ENGINEERING PEER REVIEW OF COAL BYPRODUCT DISPOSAL PLANS

KINGSTON FOSSIL PLANT KINGSTON, TENNESSEE

Project Number GR3471-01

November 2004

DATE: 27 OCT 2004 SCALE: 1" =
PROJECT NO. GR3471-01 FILE NO. 3471F004.DWG
DOCUMENT NO. - FIGURE NO. 2

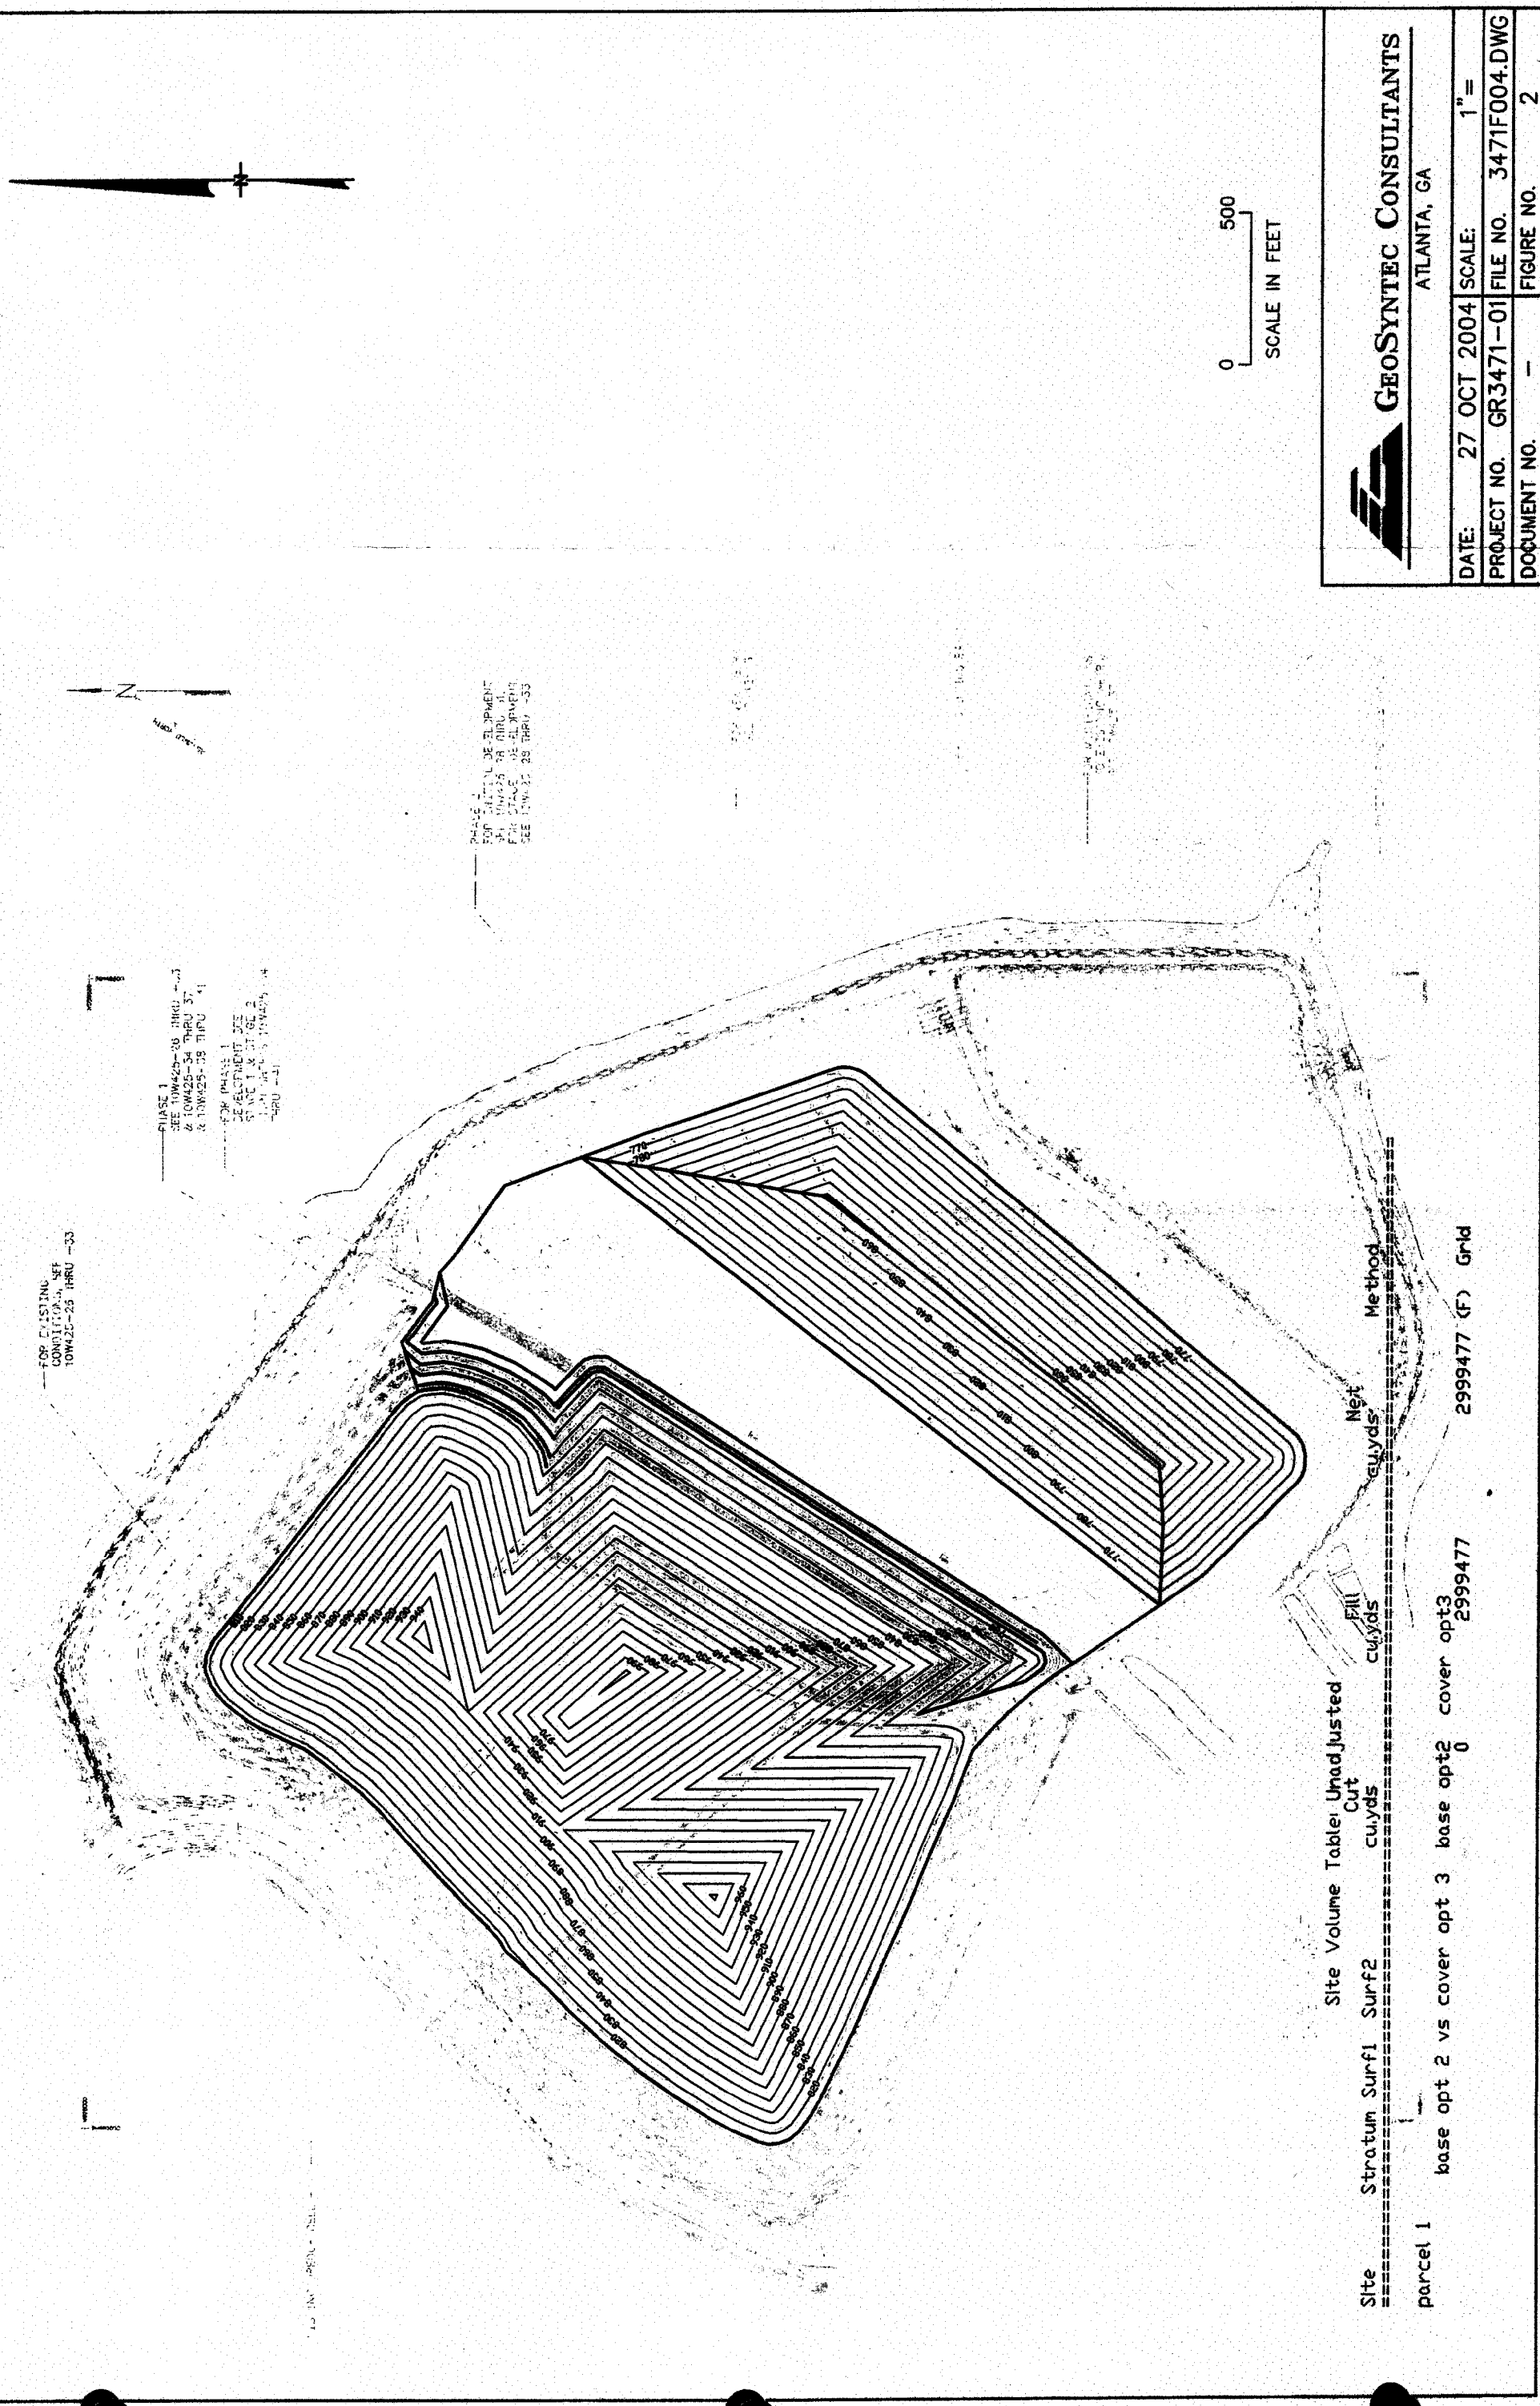
- The first option is shown in Figure 2 and was previously presented to TVA during the teleconference. This figure presents the final cover grades for both the ash and gypsum monofills. The concept maintains a 25 acre ash pond within the northwest portion of the existing ash pond and provides disposal capacity for approximately 3,000,000 cy of gypsum.

DATE:	27 OCT 2004	SCALE:	1" =
PROJECT NO.	GR3471-01	FILE NO.	3471F004.DWG
DOCUMENT NO.	-	FIGURE NO.	3

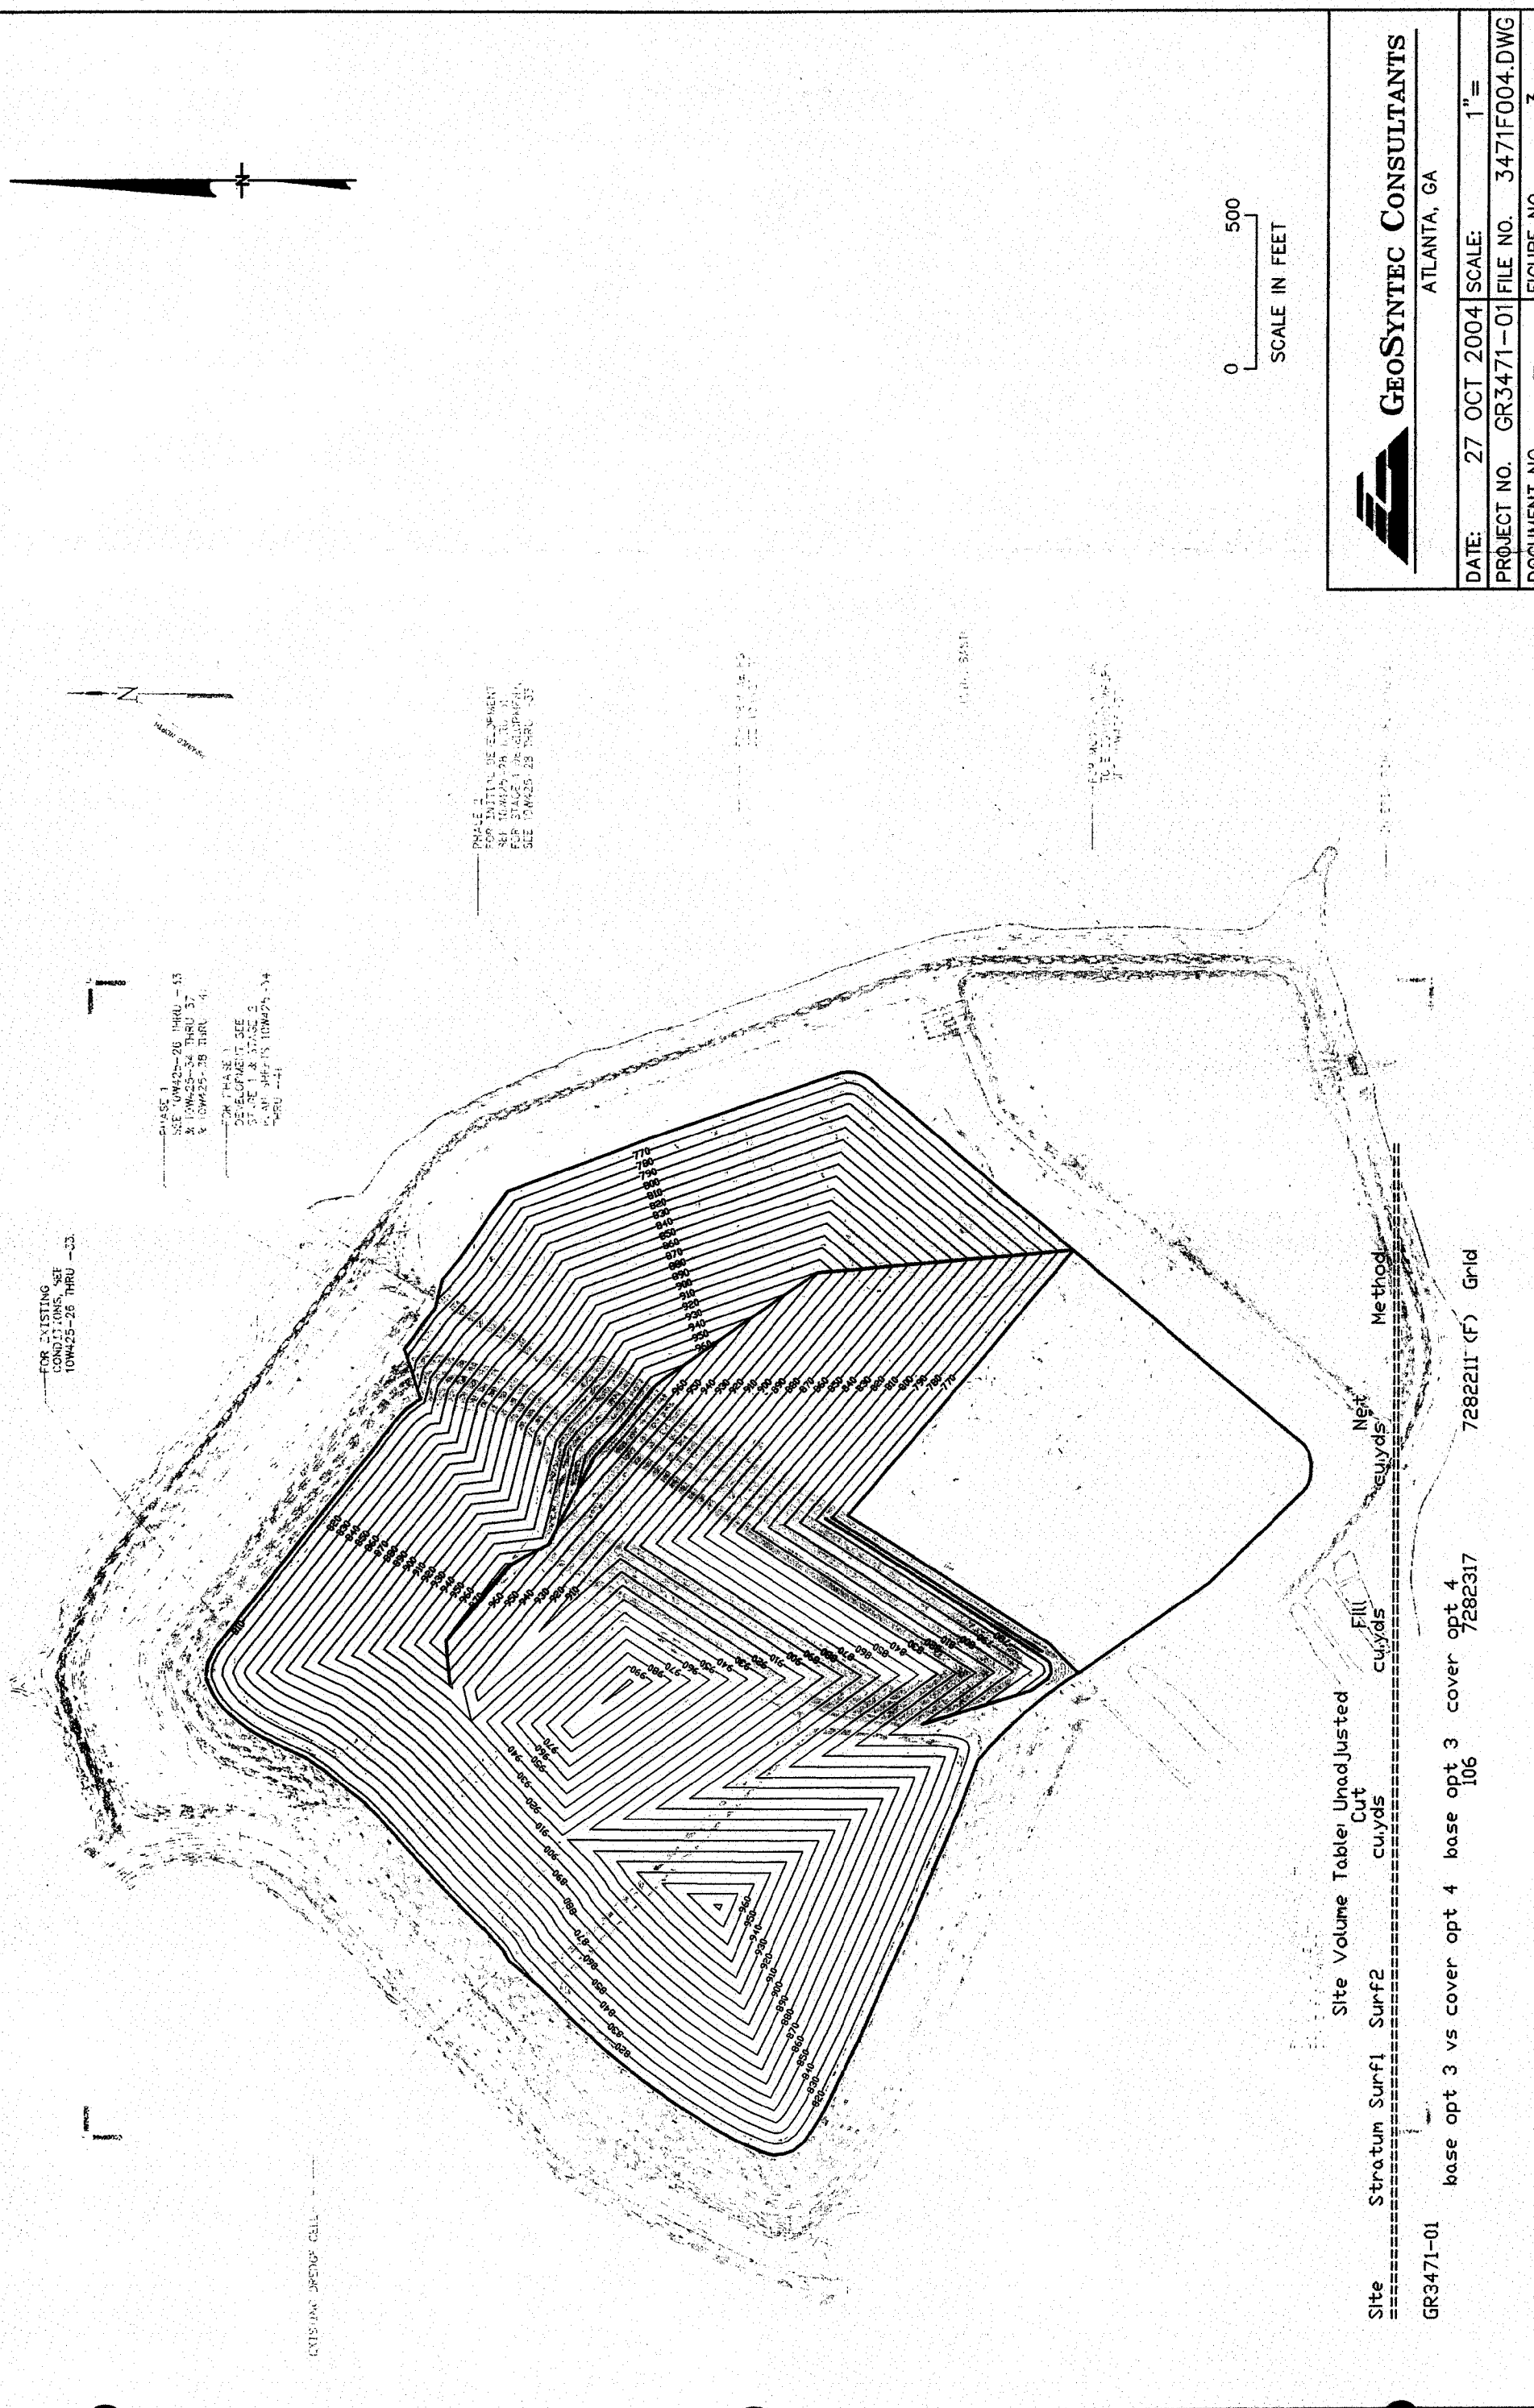
- The second option is shown in Figure 3 and was developed after the referenced teleconference. This figure also presents the final cover grades for both the ash and gypsum monofill. This concept presented on this figure also maintains the 25 acre ash pond, but limits gypsum disposal to the northeastern portion of the existing pond. Because this latter option takes advantage of the "layover" against the future ash monofill, the disposal capacity increases significantly to approximately 7,300,000 cy.
